CC-1000 Updates 5/22

Public Review: CC-1000 Updates 5-22
COMMENT DEADLINE: July 18th, 2022

Revisions Thread 1: Reconciling References, Training and Qualifications

Figure 5.4
Example of traversing structural supports

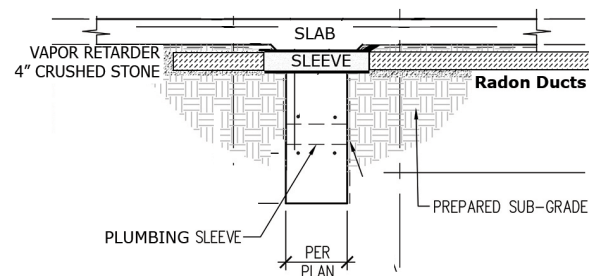
Commentary/Rational—This sentence was edited to enhance clarity. Informational notes are unnecessary.

A means shall be designed and constructed to prevent obstruction from poured concrete and collected water for openings or ducts that traverse structural supports, **such as** footings, grade beams and thickened slab areas.

~~*Informative notes—Commonly, a pipe sleeve is placed and secured prior to casting structural supports. When geotextile mats are used for ducting, the mat is commonly mounted to a flat surface to extend ducting across structural supports prior to casting concrete.*~~

Figure 9

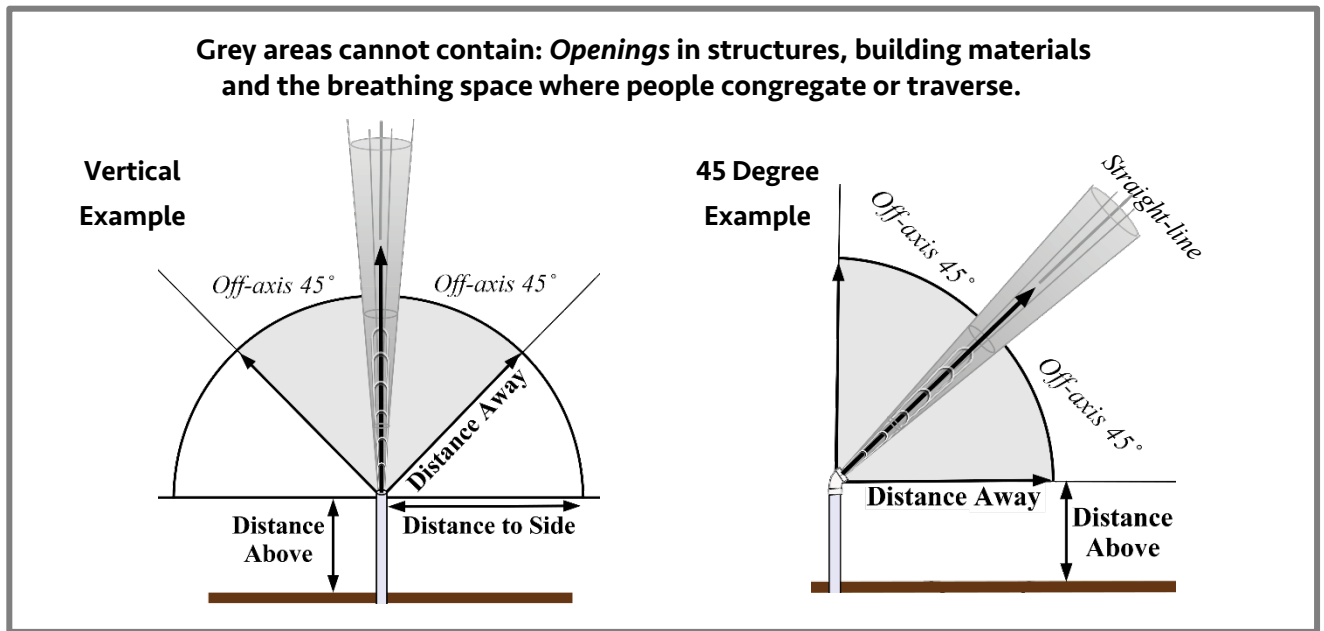
Commentary/Rational—The following replacement for Section 9 has multiple minor sentence changes that result from harmonization with ANSI/AARST RMS-MF and RMS-LB 12/20 revisions. This includes relaxation from 30ft to 20ft above grade when meeting related requirements for exhausting below the roof.

The *exhaust trajectory* with an *exhaust spread radius* of 45° shall not encounter *openings* in any structures, building materials or the breathing space where individuals congregate or traverse within 10 feet (3 m) from the *point of exhaust*.

The *straight-line exhaust trajectory* with an *exhaust spread radius* of 11° shall not encounter *openings* in any structures, attic ventilation openings, building materials or the breathing space where individuals congregate or traverse within 20 feet (6 m) from the *point of exhaust*.

9.9 Angled Trajectories

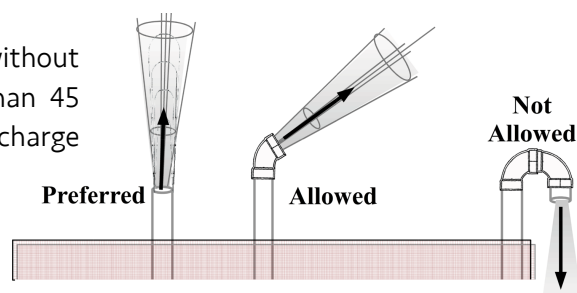
The *point of exhaust* shall be directed upward without obstruction at an angle that does not deviate more than 45 degrees from a vertical exhaust trajectory. The exhaust discharge shall not exhaust downward.

Exceptions: 90 degree horizontal exhausts shall comply with requirements in **Section 9.12**

9.10 Roof

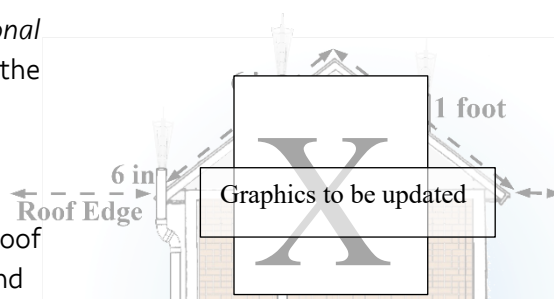
The *point of exhaust* shall comply with **Section 9.3 Directional spread** and, unless all requirements of **Section 9.11** are met, the *point of exhaust* shall be:

- not less than 1 foot (30 cm) above a pitched roof at the point penetrated;
- not less than 6 inches (15 cm) above the edge of the roof when ASD piping is attached to the side of a building; and
- not less than 18 inches (46 cm) above a flat roof; and
- not less than 4 feet (120 cm) horizontally away from a vertical wall that extends above the roof edge.
